# Groundwater Transfer Review Summary Form

Transfer/PA # T- 13484

Application: T-13484

Applicant Name: Salmon Valley Water Co

## Well Location Map

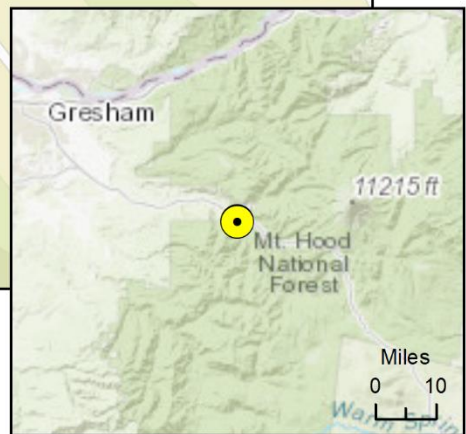
2. Will the proposed POA develop the same aquifer (source) as the existing authorized POA?  
 Yes     No    Comments: Permit G-11534 authorizes development of the alluvial aquifer system. As noted in the groundwater review for transfer application T-12040, the alluvial aquifer in this area extends to a depth of ~200 ft below land surface (bls). The proposed To-POA is completed to a depth of ~192 ft.

4. a) Will this proposed change, at its maximum allowed rate of use, likely result in an increase in interference with **another ground water right**?  
 Yes  No Comments: The distance between the original authorized From-POA location and the proposed To-POA location is negligible compared to the proximity of neighboring wells. The change should not cause an increase in interference.

5. a) Will this proposed change, at its maximum allowed rate of use, likely result in an increase in interference with **another surface water source**?  
 Yes  No Comments: The authorized From-POA location is ~1,850 ft from the nearest surface water source (the Salmon River), while the proposed To-POA location is ~1,750 ft from the Salmon River. The decreased separation of the To-POA and the Salmon River could marginally increase interference with surface water.

- b) If yes, at its maximum allowed rate of use, what is the expected change in degree of interference with any **surface water sources** resulting from the proposed change?  
Stream: Salmon River  Minimal  Significant  
Provide context for minimal/significant impact: Because of the relatively small change in separation distance from the nearest surface water and the high transmissivity of the alluvial aquifer in this area, any increase in interference with surface water is likely to be minimal.
